**DATE:** 07.10.2019  
**TO:** ProTrak  
**FROM:** Mitesh Baxi  
Traffic Engineering

■ **NHRMC DISTRIBUTION/EMS WAREHOUSE [TRC Plan Review]**

☞ Initial Review Note ☞

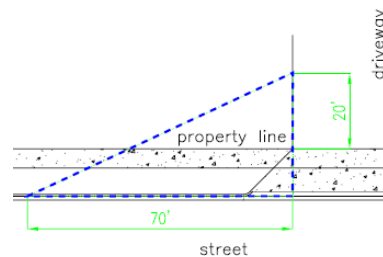
1. J R Kennedy Dr is a private access easement. Please label accordingly on the inventory plan.
2. If JR Kennedy Dr is proposed to be a public/private ROW;
  - a. The minimum street corner radii is 35'. [7-5 CofW Tech Stds]
  - b. Installation of street lights as per City's standard street lighting policy are required within the ROW.
  - c. **SIGHT DISTANCE TRIANGLE FOR ANY STREET INTERSECTIONS WITH SAID THOROUGHFARES**  
N 23<sup>rd</sup> St is a major thoroughfare [Chap VII (C) (2) (a) of CofW Tech Stds]. If J R Kennedy Dr is proposed to be a public ROW please show the sight distance triangle for the street corner. The required triangular sight distance for any street intersections with said thoroughfares shall be provided in compliance with the AASHTO sight distance standards. [Sec.18-556 CofW LDC]
